Giant Mine Environmental Assessment

IR Response Template

Round One: Information Request - Environment Canada #01

May 31, 2011

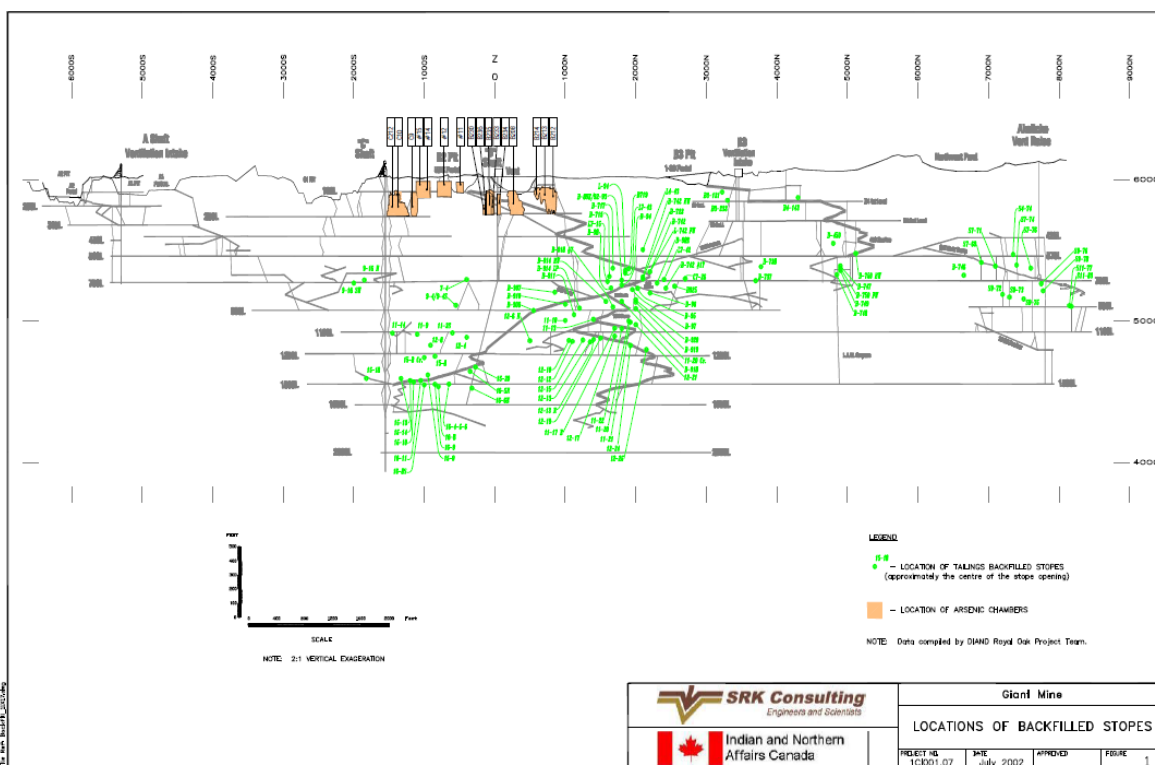
Please provide information on if there has been additional testing and attempts at this testing aimed at simulating mildly reducing conditions.

Impact of the backfilled stopes on mine water chemistry during the reflooding of lower levels of the mine was to be monitored using a Multilevel (MP) system installed in the shaft. The monitoring system was designed upon the assumption that water from the mine would be pumped out via a drill hole based pumping system located just south of the C-Shaft. The flow of mine water past the backfilled stopes and the C-Shaft to the pump inlet(s) would allow for sampling of water that had interacted with the backfilled stopes, as shown in the figure below from SRK, 2002.

However, changes in the mine water pumping system design led to it being located at the Akaitcho Shaft area. Therefore, water sampled by the C-Shaft MP system was not representative of water impacted by interaction with backfilled tailings, but rather more likely to represent water cascading down C-Shaft, or from the southern part of the mine (A-Shaft region).

Figure 1 – Map of Gridded and Discrete Receptors Used in Air Quality Modeling (150 m spacing)

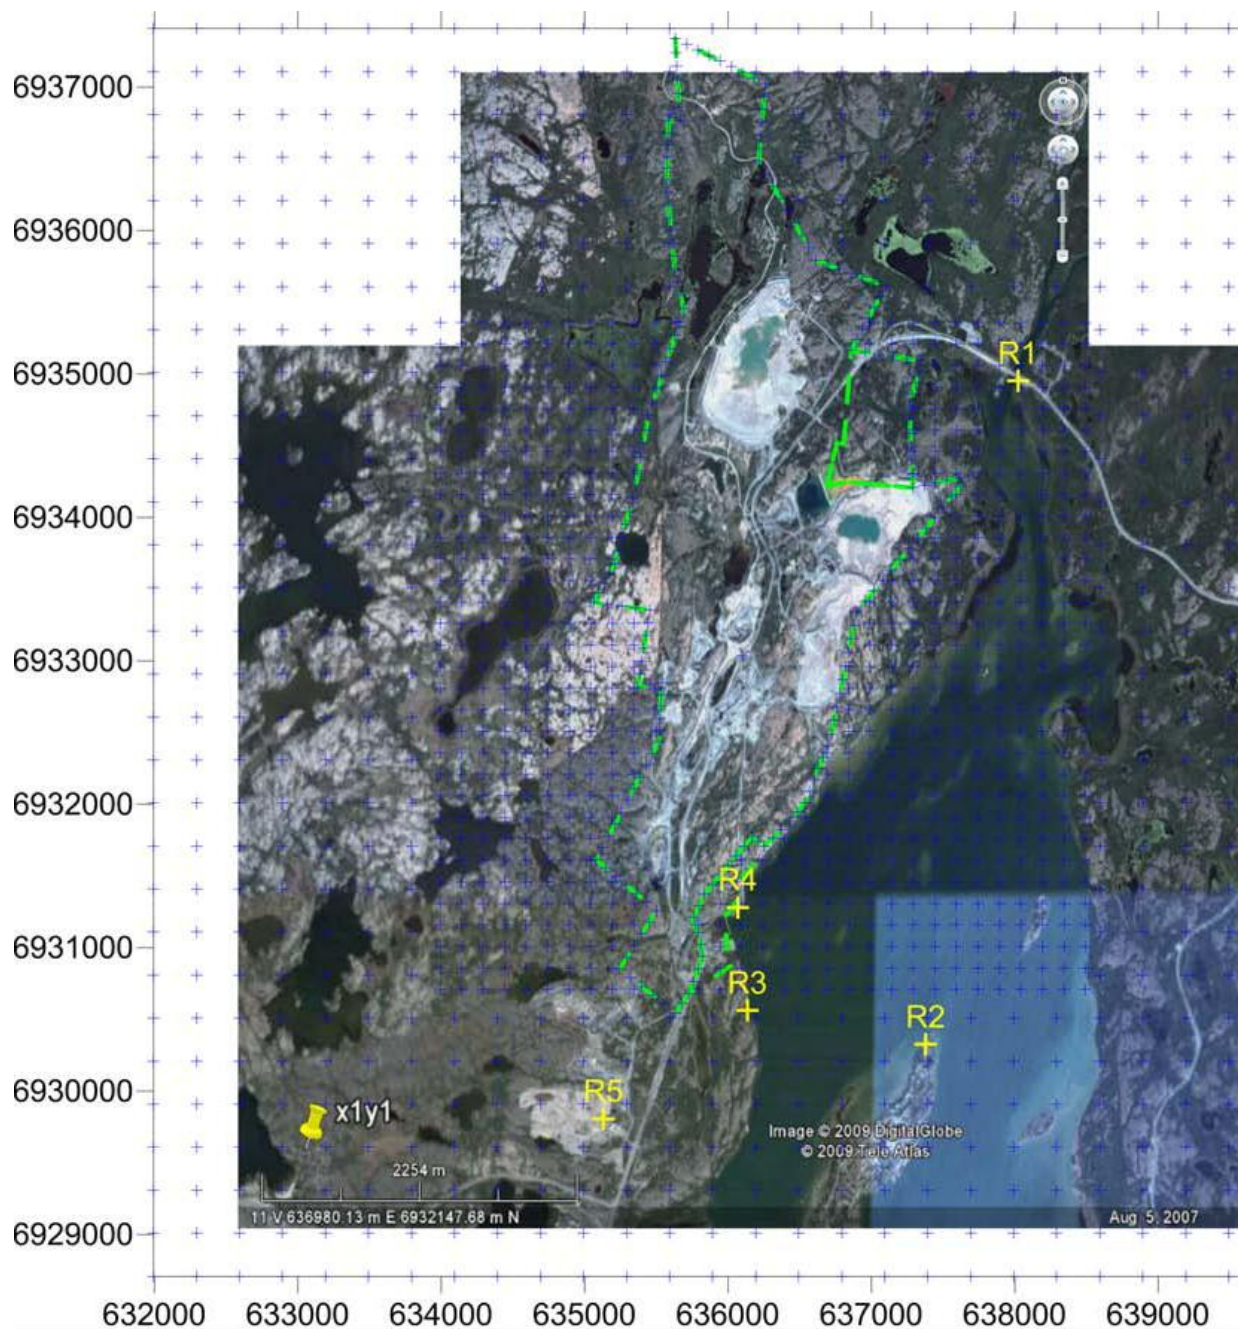
1. Environment Canada requests the following:
 - a. A map of all of the gridded and discrete receptors including spatial extent and density used in the air quality modeling;
 - b. An assessment of the potential air quality impacts from the increased load on the Jackfish Power Plant as a result of the project power demand; and
 - c. Total area of exceedance outside the disturbed mine site for each species assessed.
2. (Supplemental question from Environment Canada)

Please refer to Figure 1 below. The gridded modeling locations, which are indicated by a "+" on the figure, were on a 150 m by 150 m spacing interval.
